# Inspect Minnesota & Midwest Soil Testing

## **SUBSURFACE SEWAGE TREATMENT SYSTEM COMPLIANCE REPORT**

**Inspection Address:** 4142 Penfield Ave S, Afton, MN    **Site Conditions:** 5" Snow 0" Frost

4142 Penfield Ave S, Afton, MN 55001

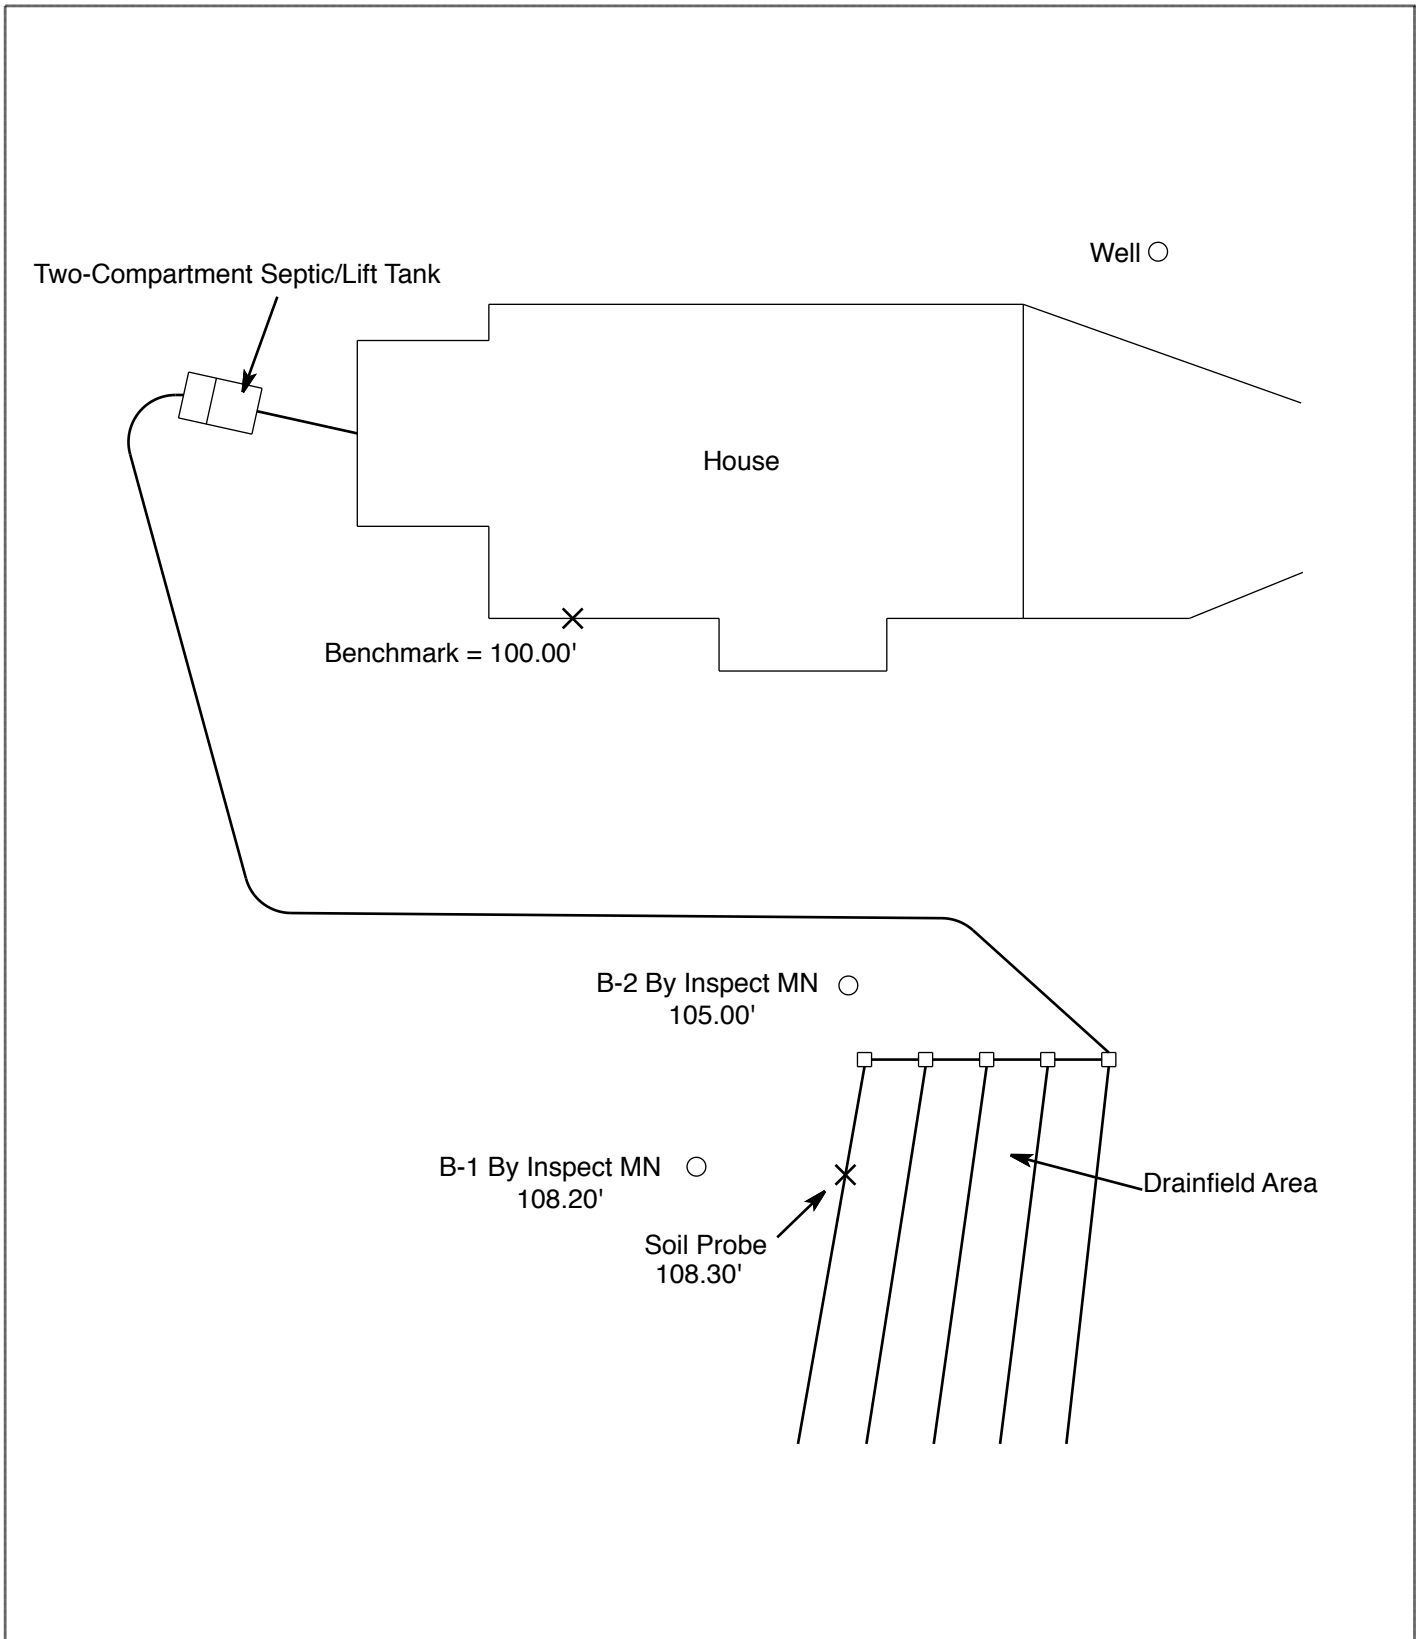
My inspection indicates that this system is presently "non-compliant" in accordance with MPCA rules 7080.1500 Subp.4(B)(E) because of the lack of the required two foot separation between the bottom of the drainfield and seasonally saturated soils. This system is not an imminent threat to public health or safety per MPCA rule 7080.1500 Subp. 4(A). Washington County issued sewage treatment permit #4626 for the installation of this septic system.

105.05'	Elevation To Bottom Of Distribution Media	105.05'	Elevation To Bottom Of Distribution Media
-105.03	Depth To Redox Or End Of Boring	-103.42'	Depth To Redox Or End Of Boring
=0.02'/0"	Of Separation	=1.63'/20"	Of Separation
End Of Boring At:		47"	End Of Boring At: 24"
Redox Present At:		38"/105.03'	Redox Present At: 19"/103.42'
Standing Water Present At:		None	Standing Water Present At: None
